# ENVIRONMENTAL REVIEW TEAM REPORT

## COPPER HILL PLANNED RESIDENTIAL DEVELOPMENT GUILFORD, CONNECTICUT

Ⓜ KING'S MARK  
RESOURCE CONSERVATION AND DEVELOPMENT AREA

FIGURE 1.

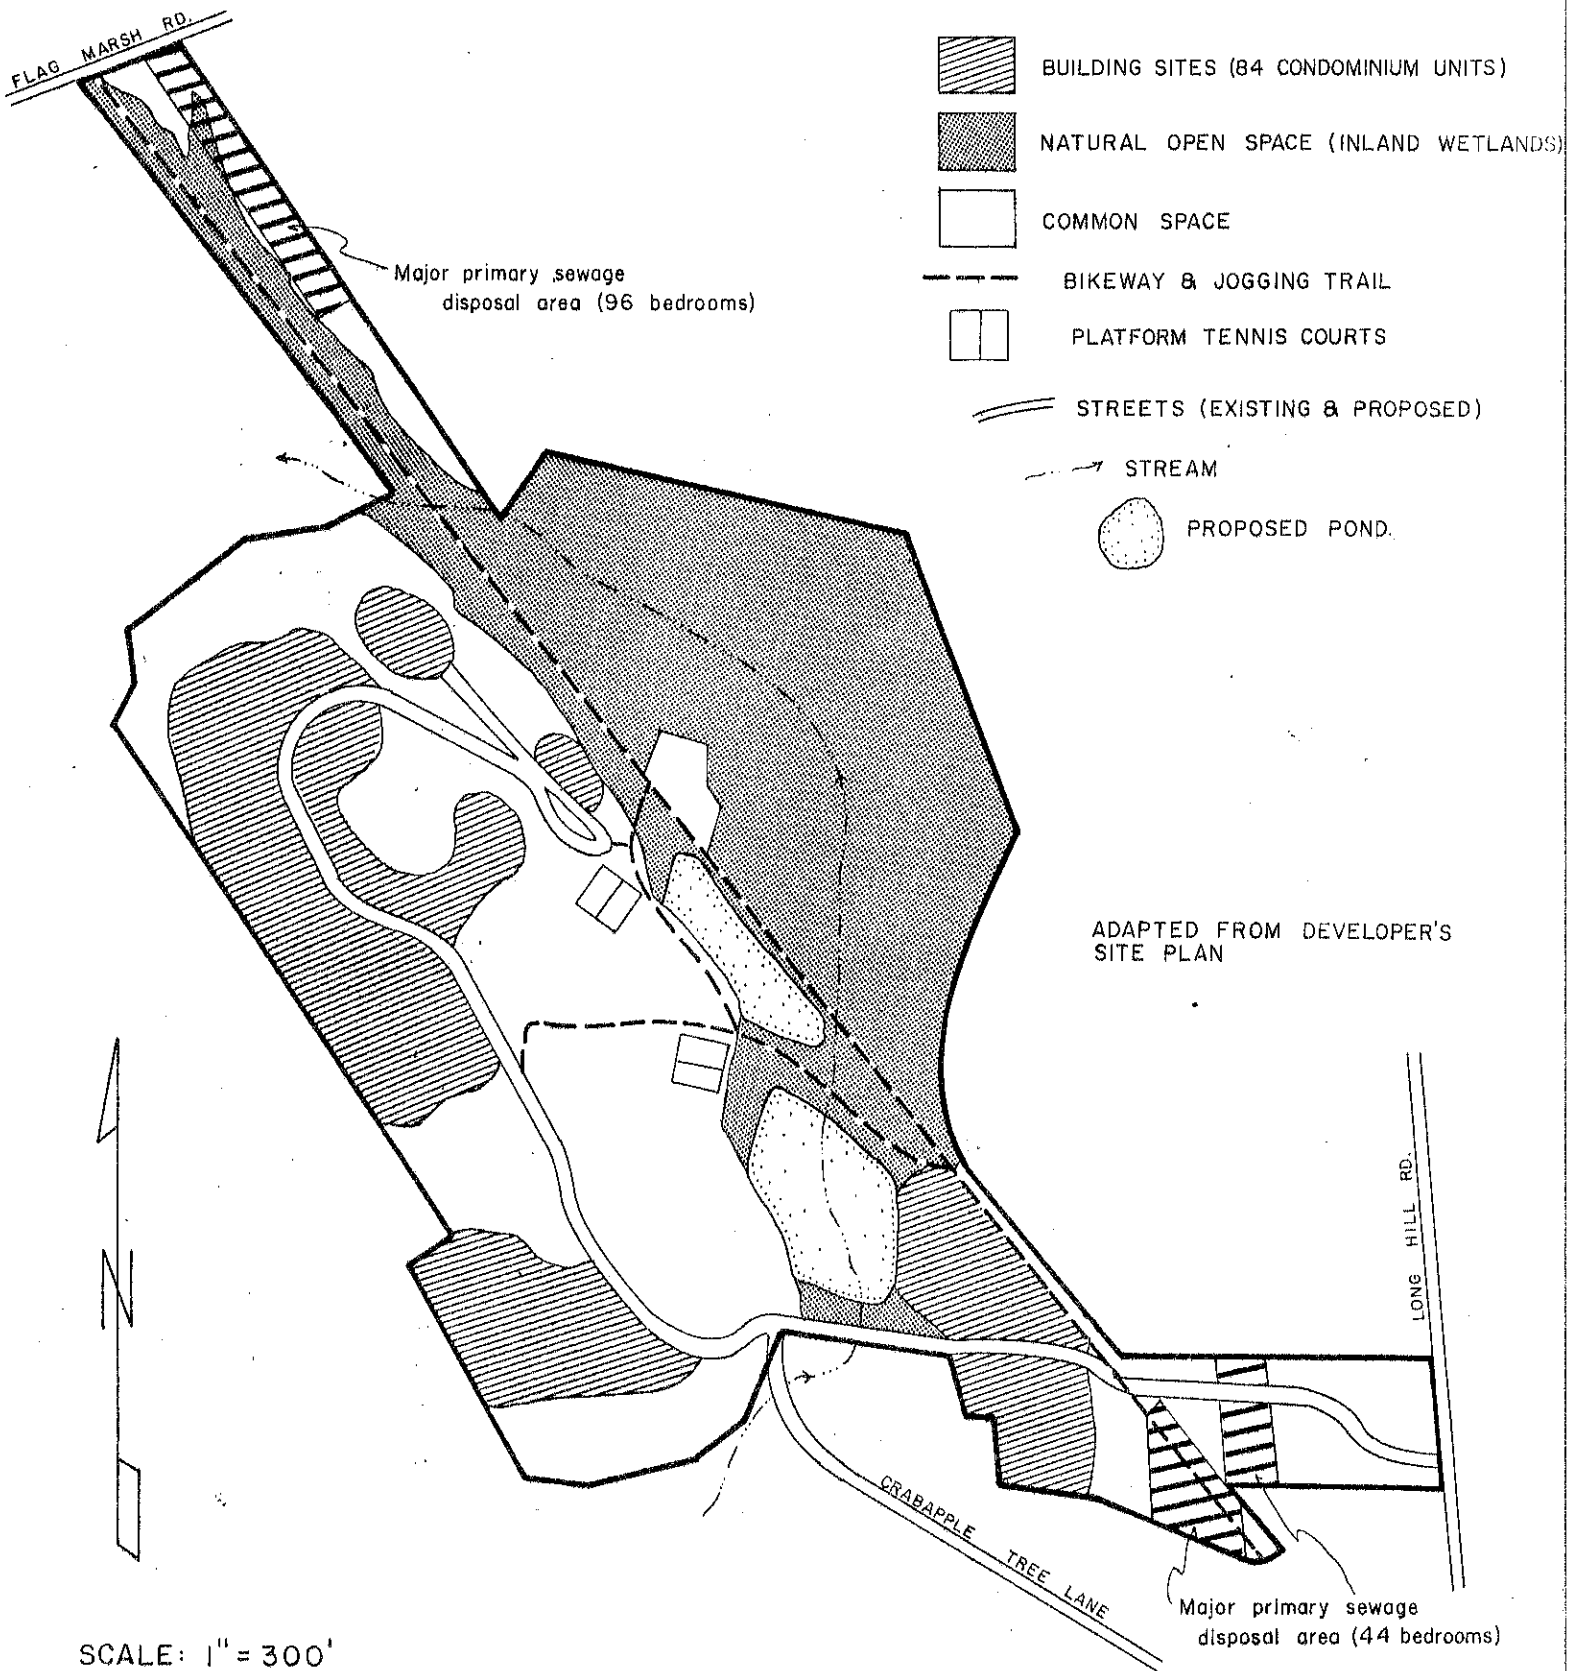
Two major primary areas for sewage disposal have been proposed. One area, in the southeastern corner of the property (see Figure 1), is proposed to service 44 bedrooms with 10,600 linear feet of leaching trench. The other area, in the northern portion of the property, is proposed to service 96 bedrooms with 1800 linear feet of 4 x 4 gallery. With a project bedroom count of 144, it is estimated that 21,600 gallons of wastewater per day would be discharged from the development into the proposed leaching fields. This substantial volume of effluent must receive adequate treatment in the soil zone prior to its discharge into the small streams and wetland on the site.

The other major area proposed for waste disposal, located in the northern portion of the property, is mapped as an inland wetland soil according to the Soil Conservation Service mapping (see Soils Map in Appendix). More detailed inland wetland mapping by the applicant indicates that a  $\pm$  1.5 acre portion of this northern area, corresponding to the eastern half of the tongue at the northern end of the property, is not wetlands. It is within the  $\pm$  1.5 acre area that most of the sewage generated by the project is to be disposed (see Figure 1).

The suitability of the land proposed for sewage disposal is one of the most critical concerns of the Copper Hill development proposal. Preliminary analysis indicates that the proposed leaching areas may not be large enough to service the proposed number of bedrooms. The importance of thorough hydraulic analysis and careful engineering cannot be overemphasized.

FIGURE 4.

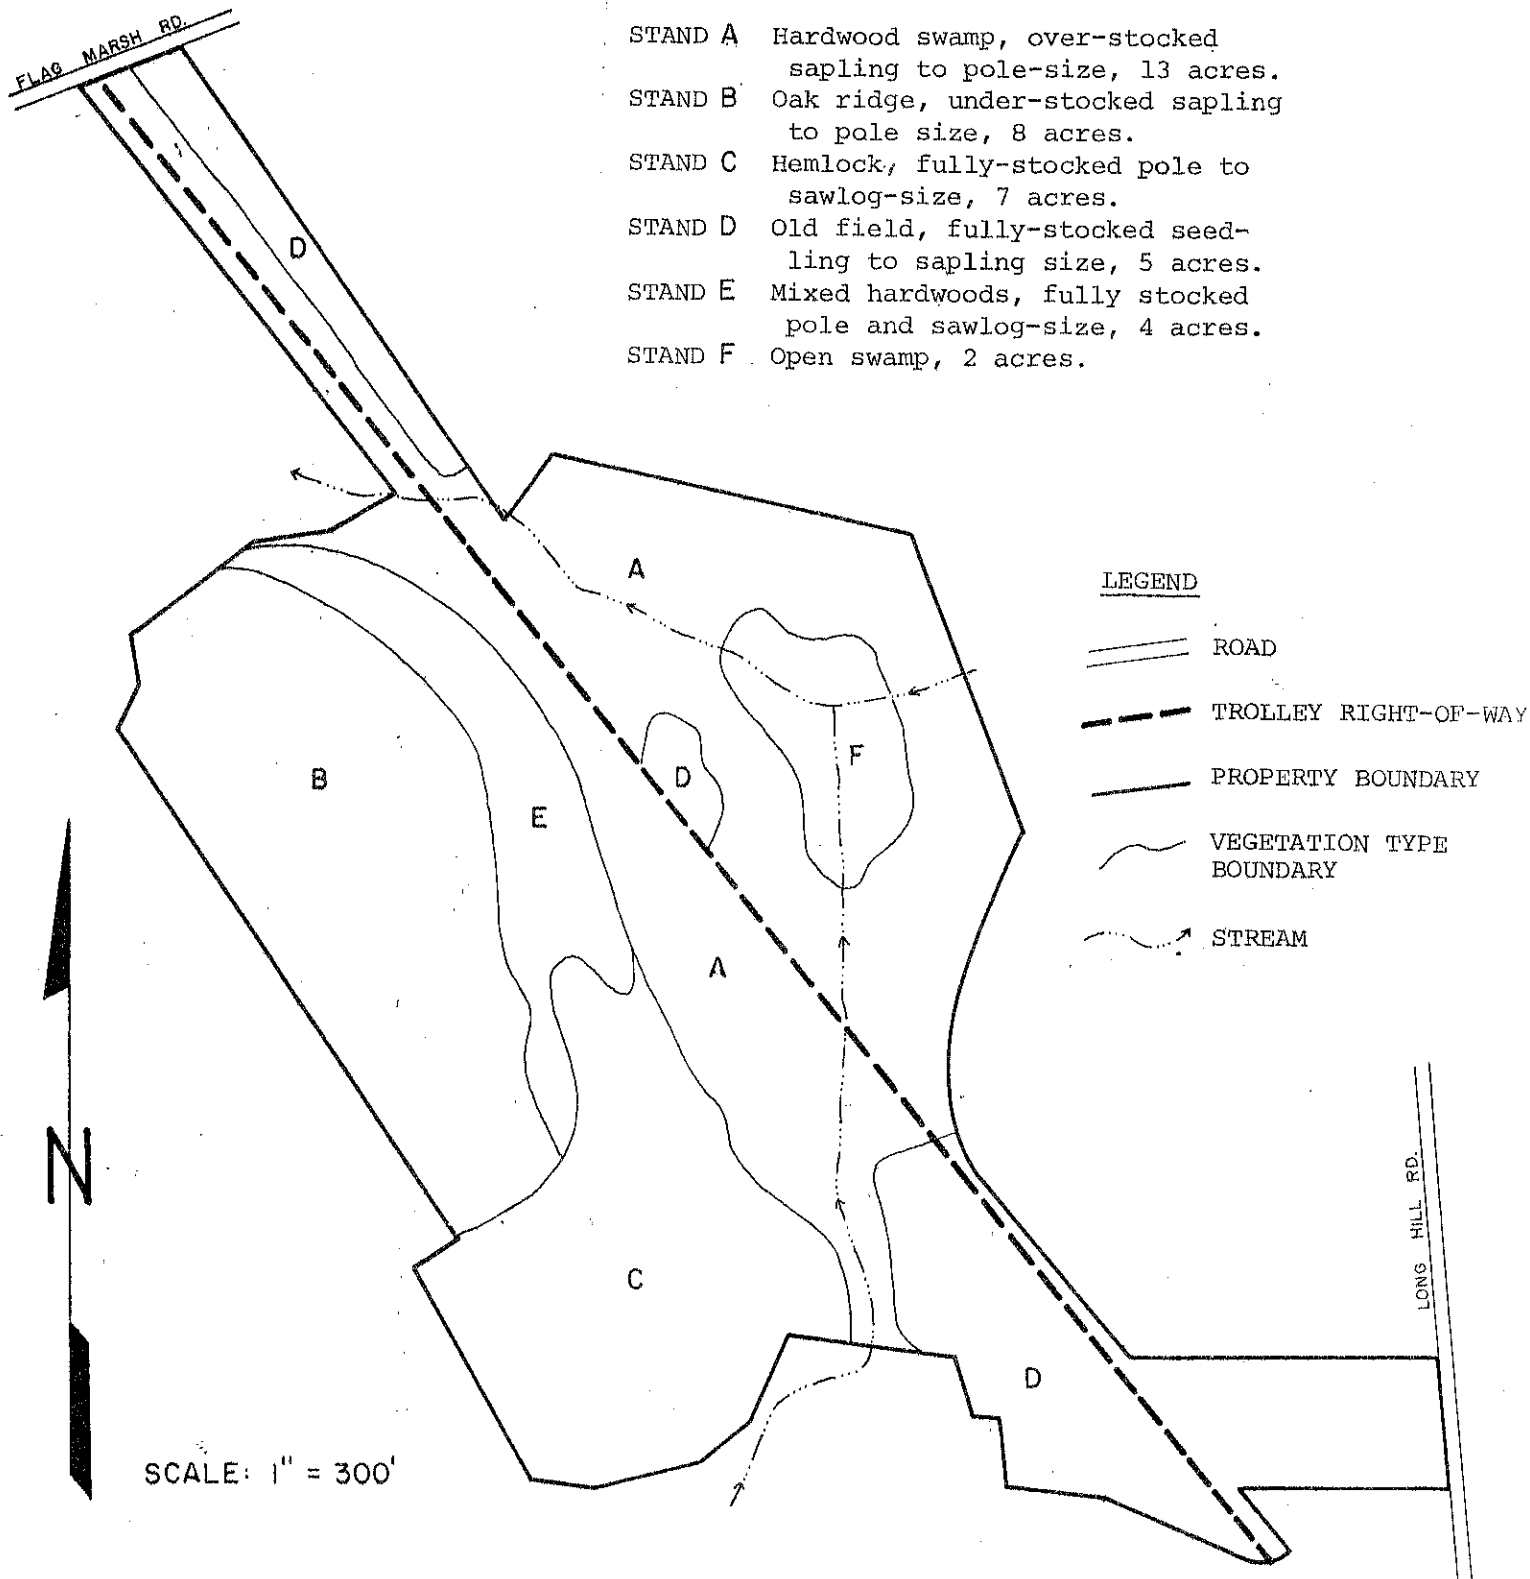
The 15 acre inland wetland located within this tract (Stand A and Stand F) has great ecological importance and should be preserved as open space. Vegetation plays a key role in the wetland's ability to store flood waters and release them slowly, reducing flooding down stream. The wetlands also serve to protect water quality by trapping sediment and biologically breaking down harmful pollutants which cling to sediments.

Windthrow may be a hazard in Stand A, B and C. The trees in the hardwood swamp (Stand A) are shallow rooted and crowded. The saturated soils in this stand do not provide a good substrate for trees to become anchored in; as a result the potential for windthrow is high. A thinning in this stand will allow trees to become more stable and wind firm over time.

A fuelwood thinning in the hardwood swamp (Stand A) would reduce stocking levels and result in a healthier, more stable residual stand less susceptible to windthrow. Approximately one-third of the volume should be removed, concentrating on unhealthy slow growing, poor quality trees and those trees directly competing with healthier higher quality trees. This thinning would be best carried out during the winter when the wetlands is frozen over. Although a commercial thinning is not feasible in Stand E, a thinning could be implemented through a fuelwood sale. Once again this thinning would reduce crowding and in time the residual trees will become healthier and better able to withstand developmental stresses. The poor quality sawlog size trees should be removed along with between one-quarter and one-third of the pole size trees.

FIGURE 5.

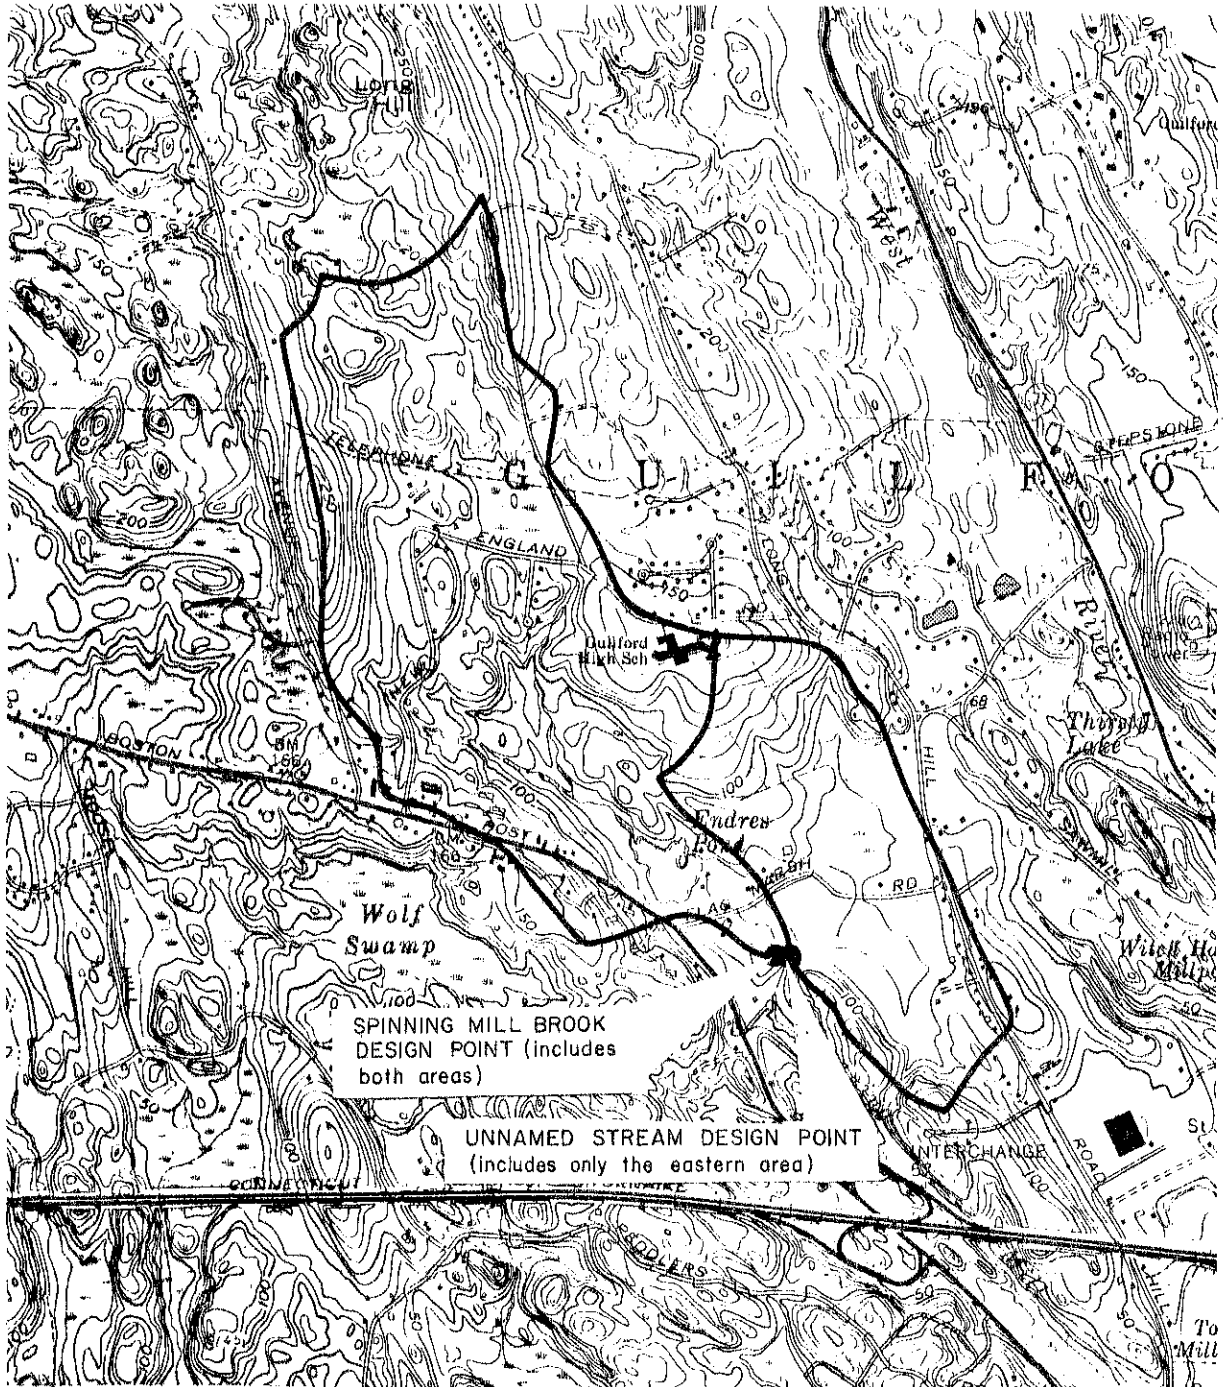
Based on a procedure outlined in Technical Release No. 55 of the Soil Conservation Service, it is possible to estimate the magnitude of the peak flow increases to be expected in the two watercourses following development. The procedure involves an analysis of the drainage areas of the watercourses, including such factors as size, slopes, land uses, and soil types. The two drainage areas of concern for this study are shown in Figure 5, along with their respective design points (points of discharge). It was assumed that all water from the developed area would be carried either naturally or artificially into the wetland area of the site (although under completely natural drainage conditions, some runoff would flow westward, directly into the brook).

It is estimated that peak flows in the stream would increase approximately 10 percent for a 25-year frequency, 24-hour duration storm, and approximately 8 percent for a 50-year, 24-hour storm. Peak flows in the brook would increase approximately 3 percent for either storm. These increases may cause some additional erosion along the banks of the streams, but they would not, by themselves, be expected to add significantly to flood elevations in the area. As a matter of policy, however, it would be desirable to regulate flows in the stream to prevent any peak flow increases in the brook, since a number of future developments that could occur in the brook's drainage area ultimately could produce significant additional flooding. Flow regulation in the stream could be accomplished by outlet control from the proposed ponds, if these are also used as runoff detention basins.
